SUBJECT: WOLF CREEK GENERATING STATION - ISSUANCE OF AMENDMENT RE:  
MODIFICATION OF IMPROVED TECHNICAL SPECIFICATIONS (TAC NO.  
MA7792)

WOLF CREEK GENERATING STATION

Amendment No. 132  
License No. NPF-42

SAFETY EVALUATION BY THE OFFICE OF NUCLEAR REACTOR REGULATION  
RELATED TO AMENDMENT NO. 132 TO FACILITY OPERATING LICENSE NO. NPF-42

Figure 3.5.5-1 (page 1 of 1)  
Seal Injection Flow Limits

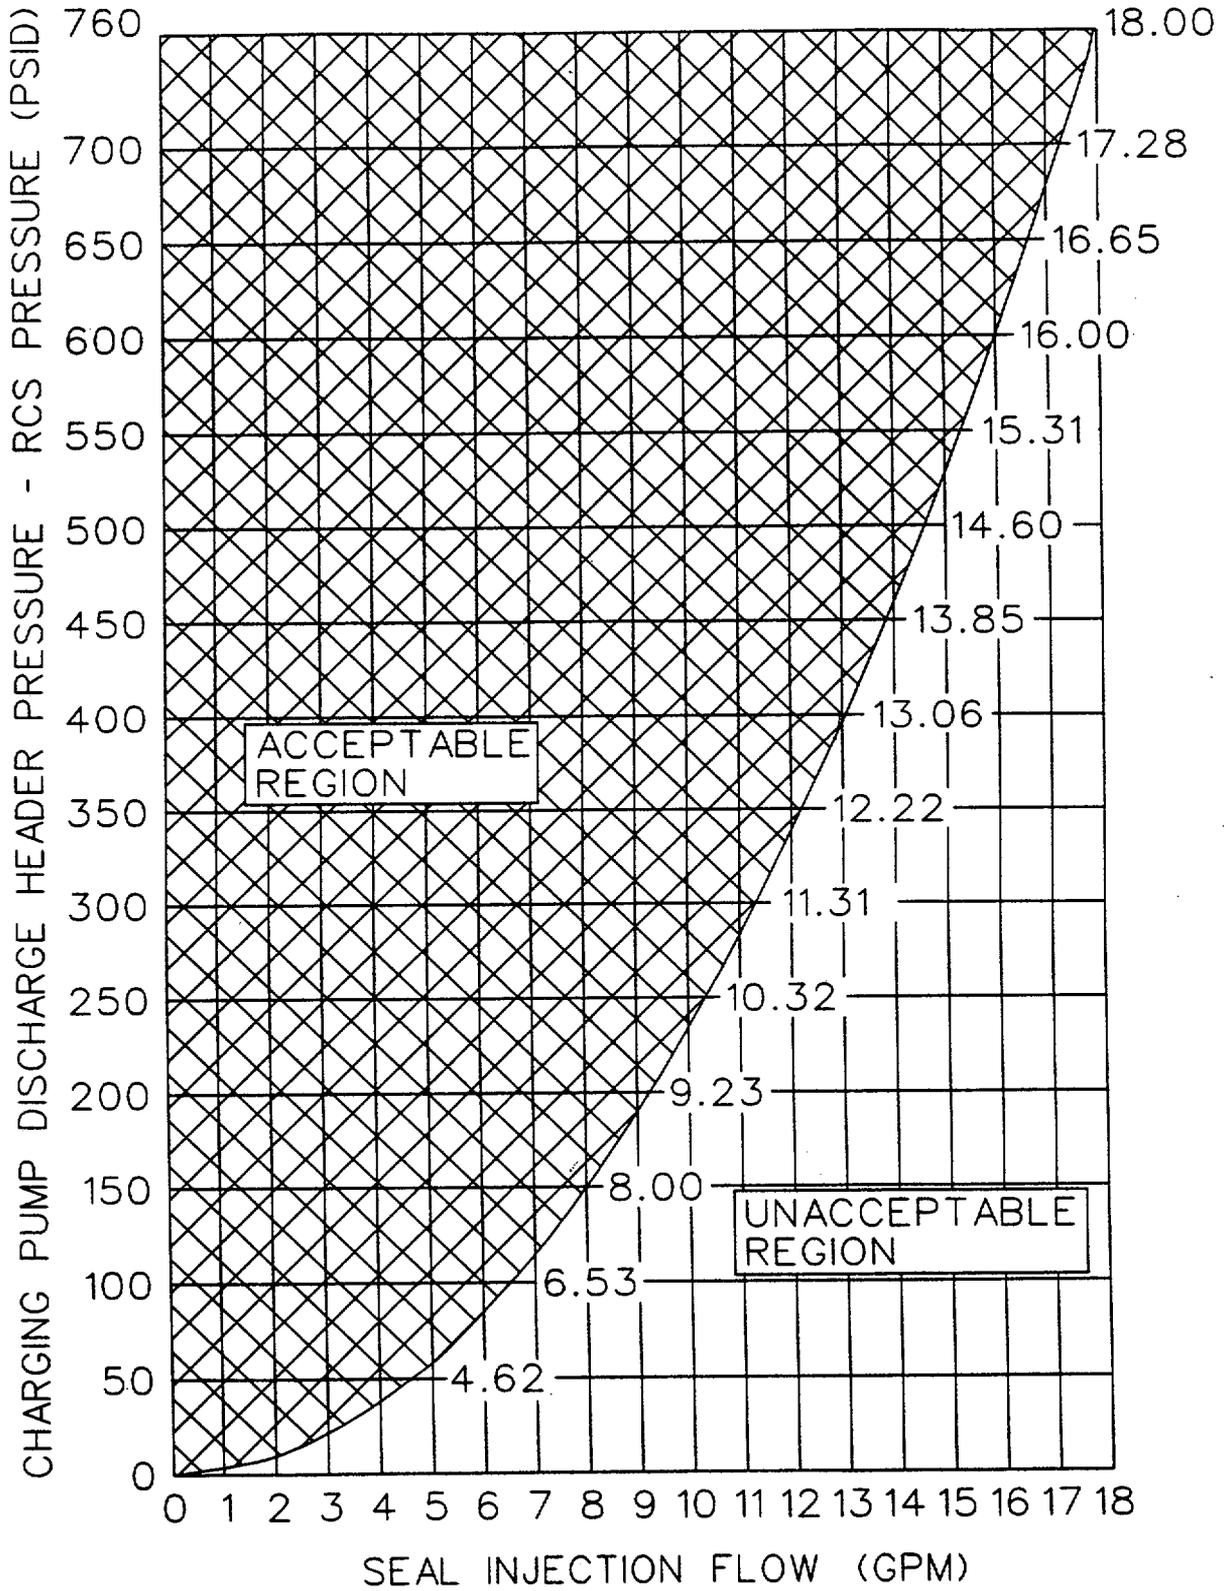
The proposed changes expand the region of acceptable reactor coolant pump (RCP) seal injection flow to each RCP in Figure 3.5.5-1 and provided the following 10 editorial changes: (1) delete the redundant "%" sign in the allowable value for function 4 in Table 3.3.1-1 on reactor trip system instrumentation, (2) delete the extra spacing in the description of function 20 in Table 3.3.1-1, (3) insert periods at the end of the text for Conditions M and N in the actions for limiting condition for operation (LCO) 3.3.2 on engineered safety features actuation system instrumentation (ESFASI), (4) spell "requirements" correctly in function 5.c of Table 3.3.2-1 for ESFASI, (5) delete the invalid "SR 3.3.2.6" from the surveillance requirements column for Function 7.a in Table 3.3.2-1, (6) align the wording "Coincident with Safety Injection" with the title of Function 7.b in Table 3.3.2-1, (7) align the data in the 4 columns of Table 3.3.7-1, CREVS [control room emergency ventilation system] Actuation Instrumentation, for Function 3 with the first line of the title of the function, (8) align the specified completion time in Condition B of the actions for LCO 3.7.1 for main steam safety valves with text for the Required Action B.2, (9) add the acronym "EES" to Emergency Exhaust System in the table of contents and use the acronym in the upper right-hand-corner of the 4 ITS pages for LCO 3.7.13 on the emergency exhaust system, and (10) uncapitalize the word "Associated" in Condition B of the actions for LCO 3.8.4 on DC sources - operating because it should not be capitalized.

The licensee stated that the proposed changes to Figure 3.5.5-1 will extend the bounds of the acceptable range of seal injection flow to encompass the entire range of acceptable seal injection flow. The range of low seal injection flow is extended to zero flow, below the 6.53 gpm in the current figure, even though the normal operating range of seal injection flow is 8 to 13 gpm per RCP. If the flow is less than 6 gpm, procedure OFN BB-005, "RCP Malfunction," will provide the actions needed to restore seal injection flow; however, this low flow rate is not a safety concern because the RCP thermal barriers would provide sufficient cooling to the pump water bearing and shaft seal if there was no seal injection flow.

The upper part of the curve in Figure 3.5.5-1 is also extended to 18 gpm from the 10.33 gpm in the current figure. This is to depict the flow limit at higher differential pressures which potentially could occur at low RCS pressure. The CCP discharge header pressure is essentially constant and a reduction in RCS pressure would result in more seal injection flow than at normal operating pressure for the settings of the seal injection throttle valves. The upper flow limit was expanded to include the flow for the maximum expected differential pressure during a large break LOCA. The upper seal injection flow limit of 18 gpm per RCP remains within the safety analysis assumptions for the large break LOCA.

The proposed Figure 3.5.5-1 is based on the safety analysis assumptions to ensure that there is sufficient safety injection flow into the RCS for cooling the core during a LOCA.

Because the acceptable seal injection flow limits in the proposed Figure 3.5.5-1 are within the safety analyses for LOCAs at WCGS, including the large break LOCA, the staff concludes that the proposed figure is acceptable.
